TO: Randy Foulke
PROJECT #: 25-1093-A
PAGE: 1 of 2
DATE: November 4, 2025
LOCATION: 203 A D Hall, Sanford NC
PLAN REF: Foulke Residence by South Designs
Project# 25-1093

THE FOLLOWING CHANGE(S) OR PROPOSED CHANGE(S) LISTED BELOW ARE
DEVIATIONS OR CLARIFICATIONS FOR THE ABOVE REFERENCED PLANS:

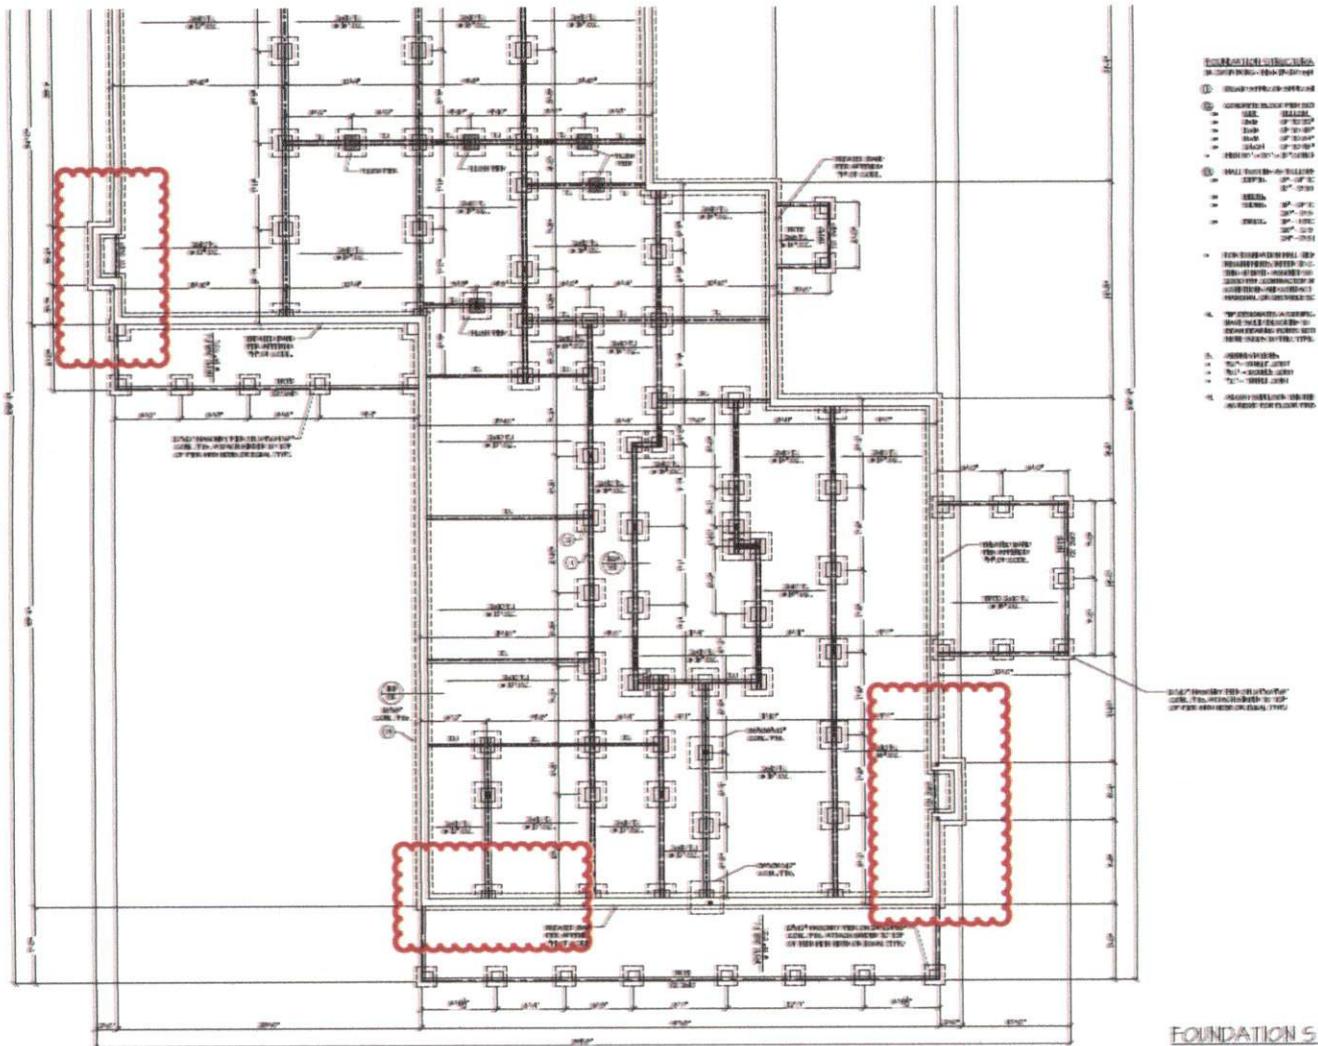
Footing Projections: Per information collected on October 30th, 2025 during a site observation the three areas marked in the image below did not have adequate projection and require additional footing.

Response: Additional concrete shall be added in the marked locations according to detail 124C-SD included below.
